| Project:  | 76 Priory Road, NW6 3NT<br>Mr. & Mrs. W. Grigull | 76PR   |
| Proposed: | Site Plan                                        | P001   |
| Status:   | Planning                                         |        |
| Date:     | January 2008                                     | Rev: A |

| Proposed: | Roof plan                                        | P006   |

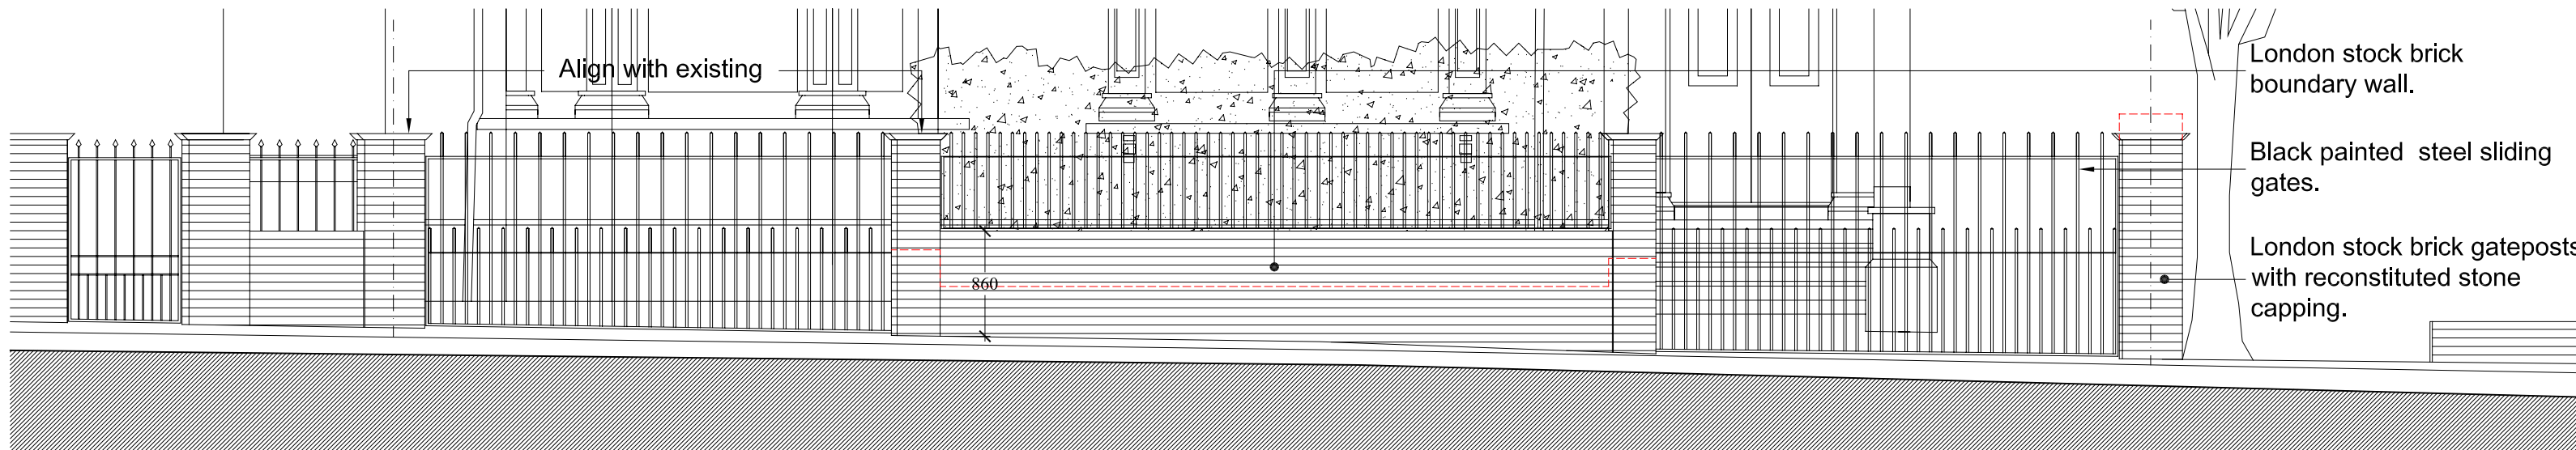
Rev A: 05-03-2008  
^Mansard roof on side entry annex revised to Hip roof form.  
^Chimney note added.  
^Railings to front light well removed & horizontal grill added.  
^Roof lights to sit flush with roof profile.  
^Rear dormer windows revised to sit within existing position.

Rev B: 06-03-2008  
^Rear Dormer windows revised to match existing conditions.  
^Rear Dormer windows revised to Timber frames.  
^Rear LGF & FF window notes revised.  
^Detail Section EE added.

| Proposed: | West Elevation (Priory Road)<br>Status: Planning | P007             |

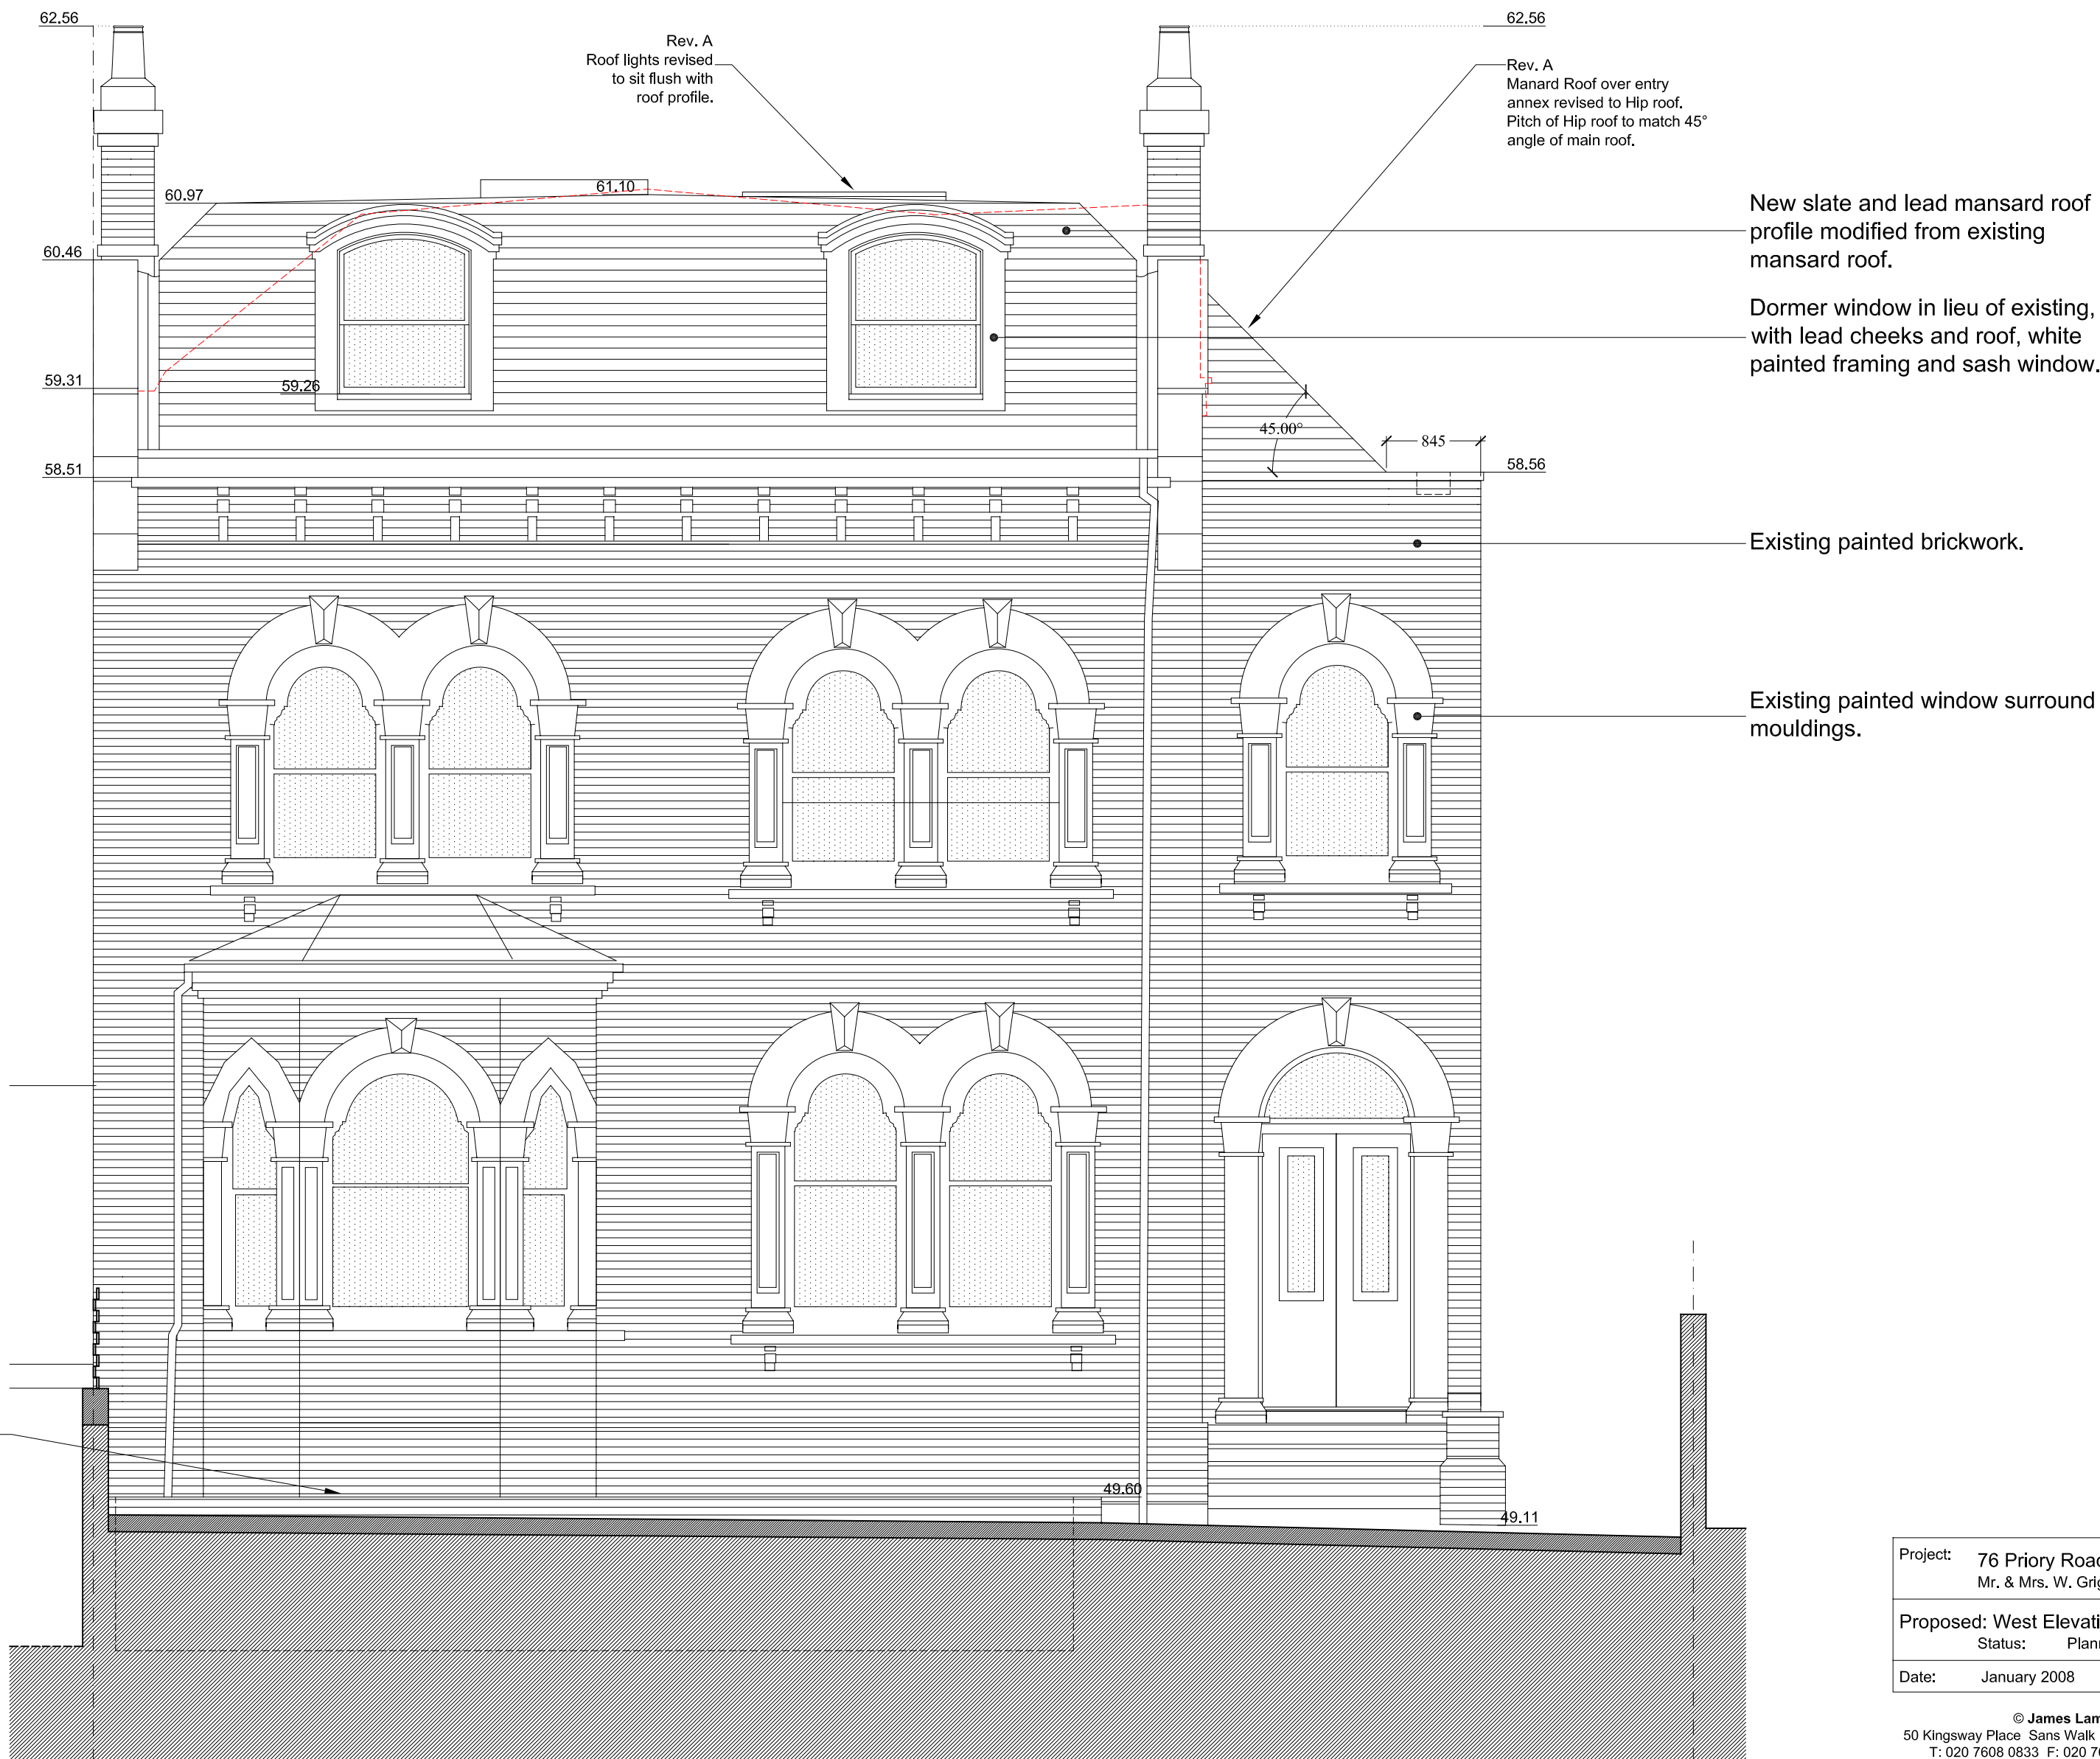
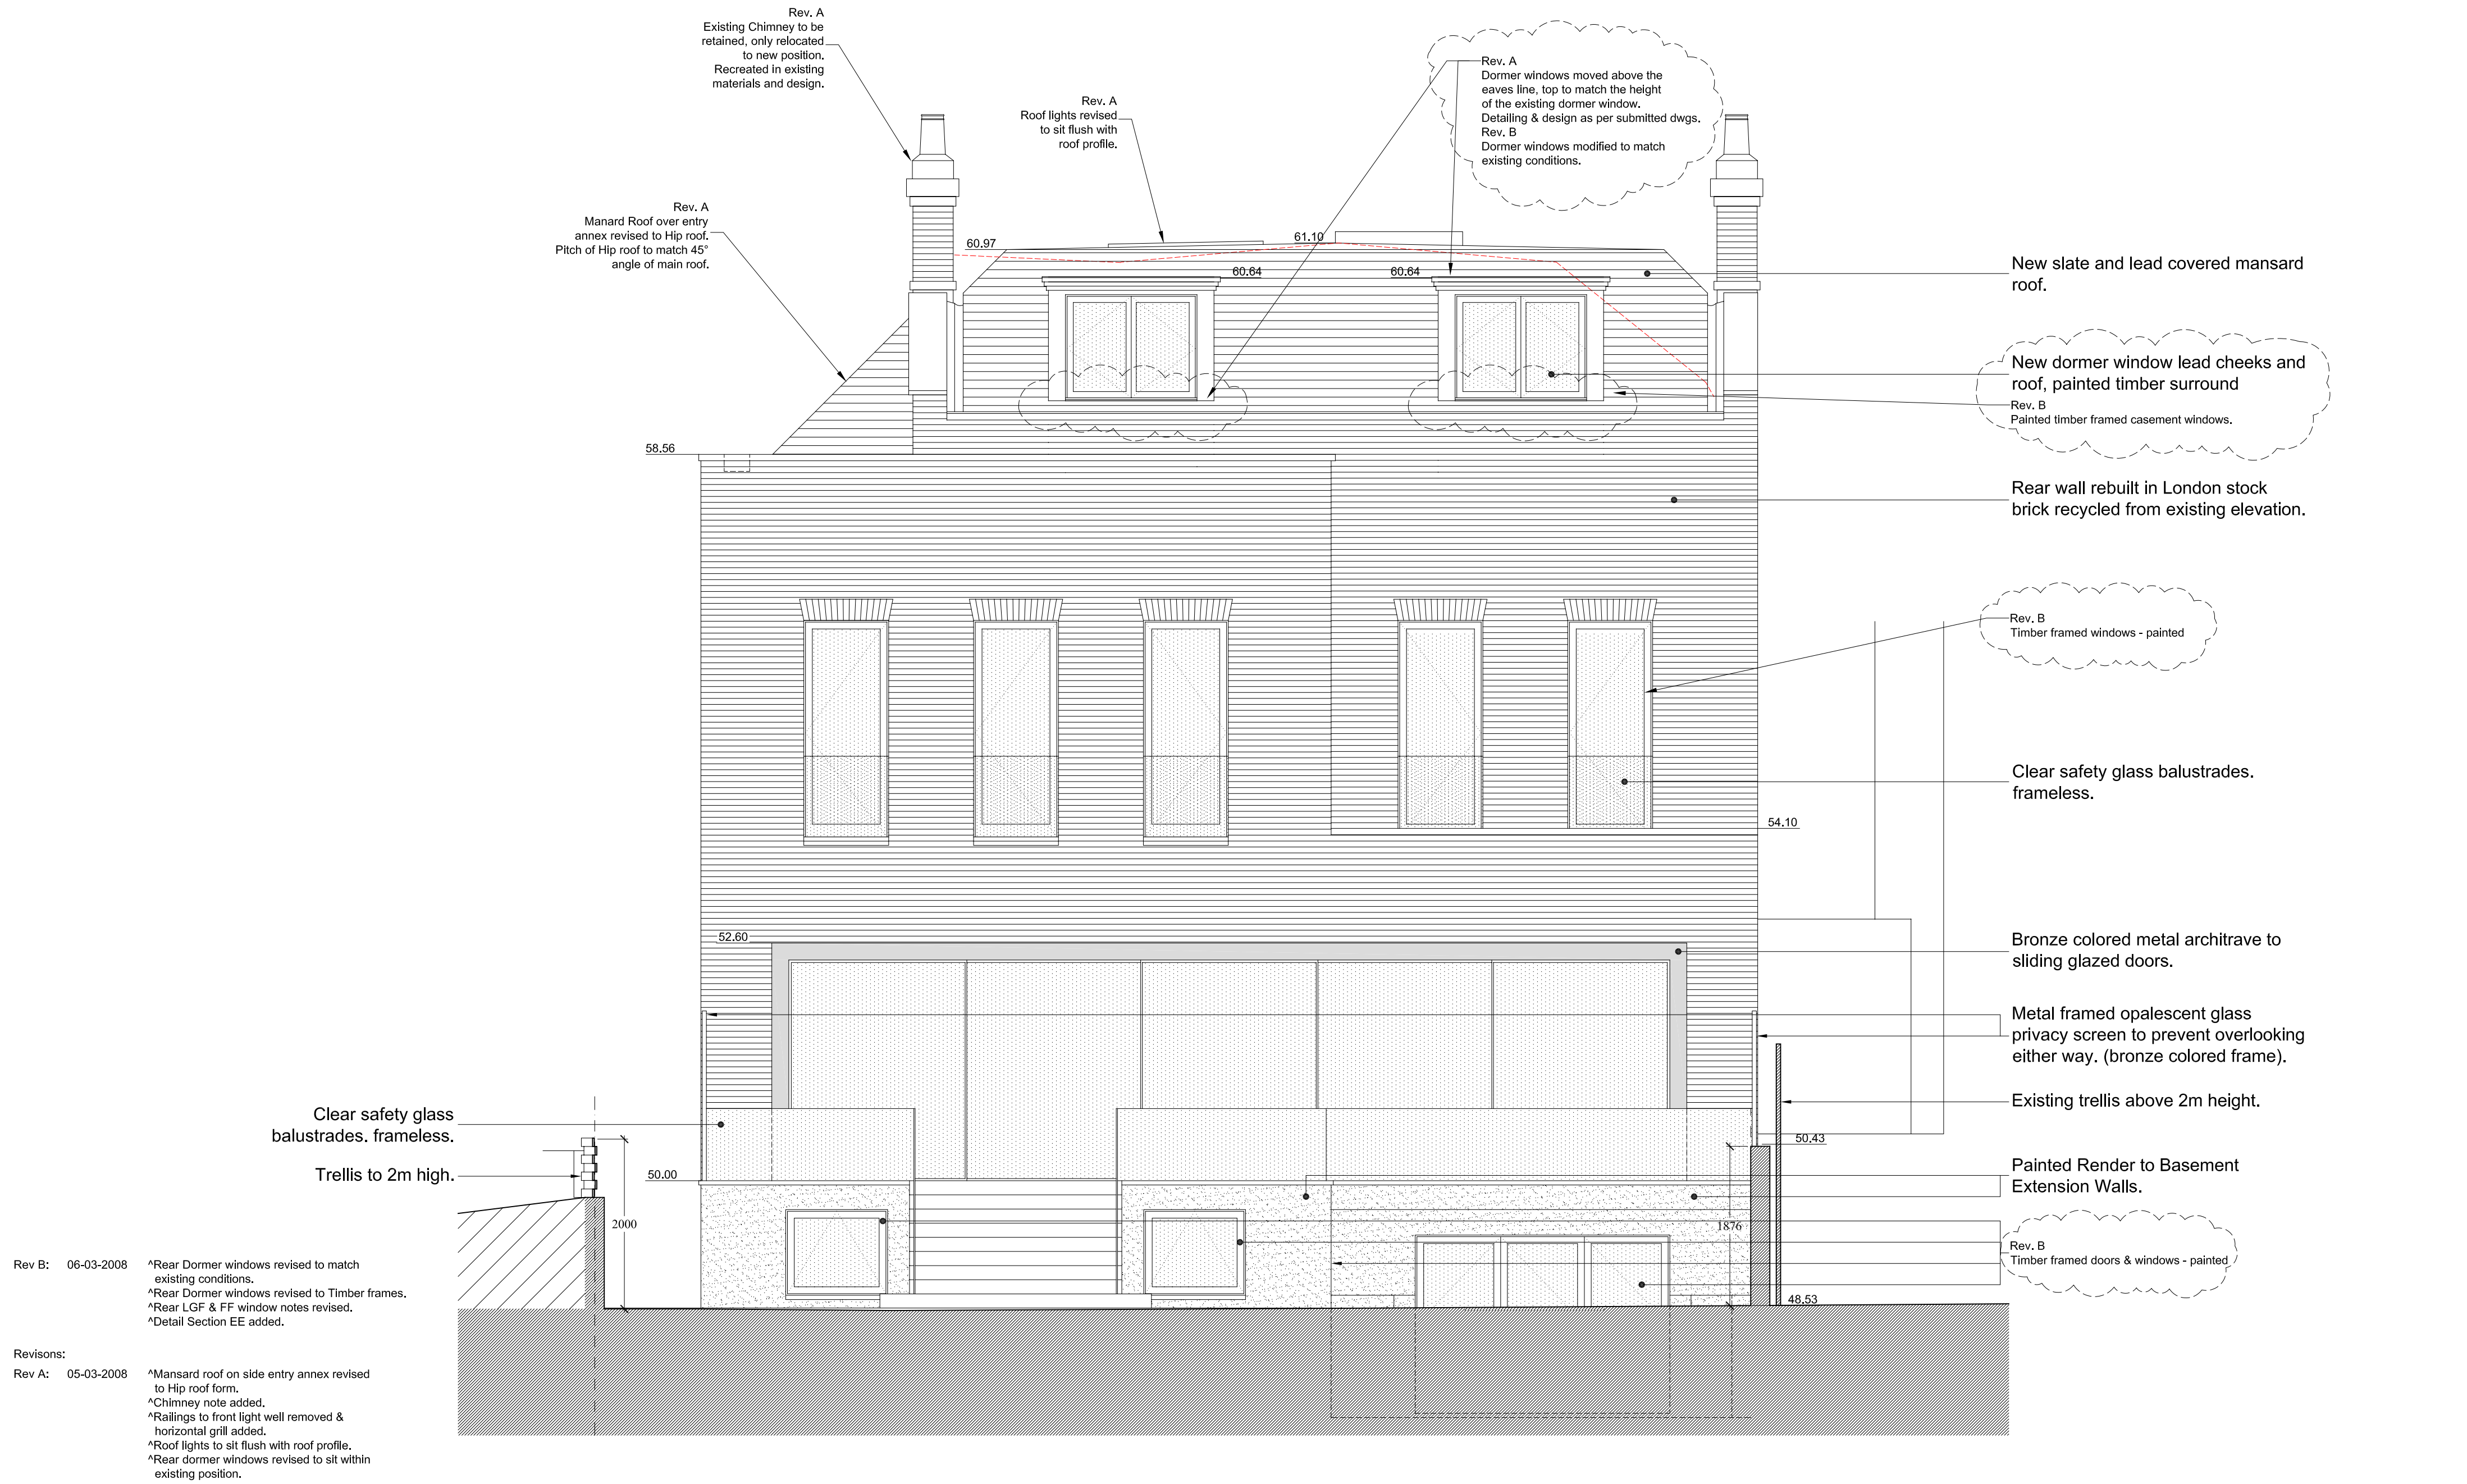
Revisions:  
 Rev A: 05-03-2008  
 \*Mansard roof on side entry annex revised to Hip roof form.  
 \*Chimney note added.  
 \*Railings to front light well removed & horizontal grill added.  
 \*Roof lights to sit flush with roof profile.  
 \*Rear dormer windows revised to sit within existing position.
